**ADDENDUM #1**

Project Title  
**CITY OF WINNIPEG  
COOLING PLANT REPLACEMENT  
151 PRINCESS STREET  
BID OPPORTUNITY 887-2012**

Drawing Title  
**MACHINE ROOM COOLING PLANT  
PLANS AND SECTIONS**

**SIXTH FLOOR MACHINE ROOM PLAN - NEW CONSTRUCTION**  
1/4" = 1'-0"

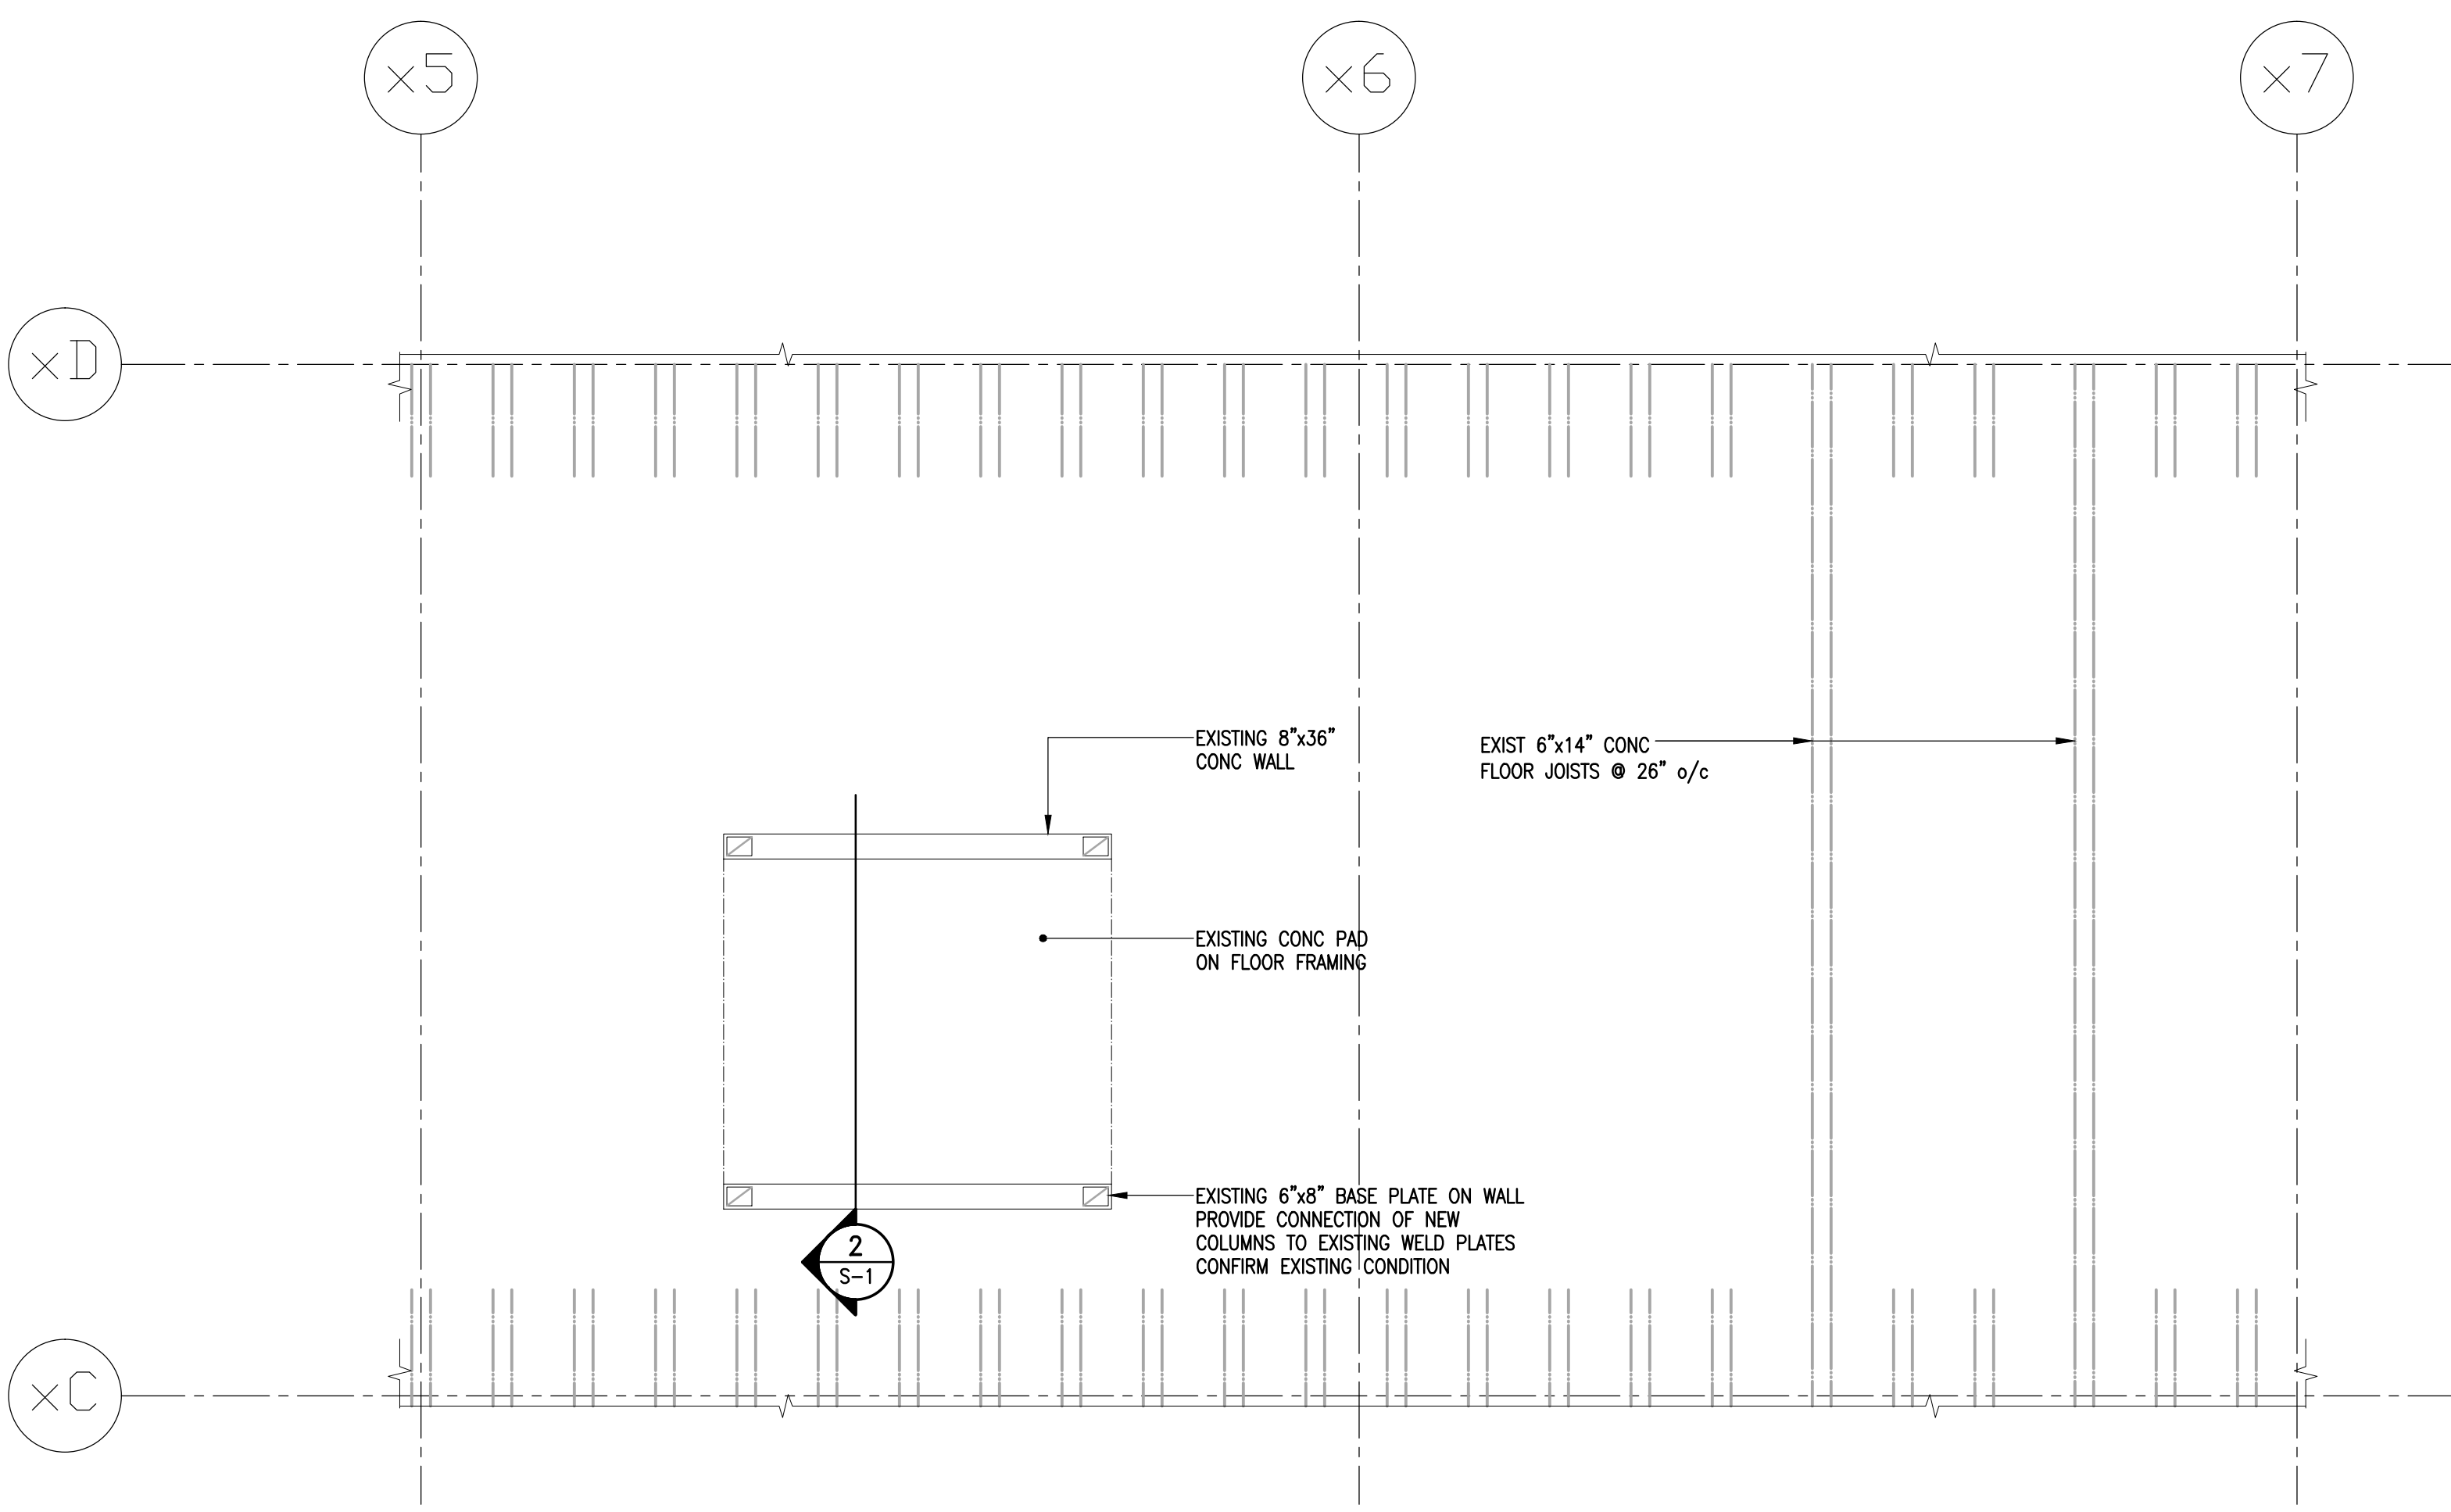
- NEW HOLE FOR CHILLER RELIEF VALVE (1.5" DIAMETER) MAY BE CORED THROUGH ROOF DECK AREA BETWEEN CONCRETE JOISTS AS NOTED ON MECHANICAL. DO NOT DAMAGE EXISTING CONCRETE JOISTS. SEAL ANCHORING.
- SEALED SHOP DRAWINGS ARE TO BE PROVIDED FOR STEEL FRAMING CONNECTIONS AS PER GENERAL NOTE #14.
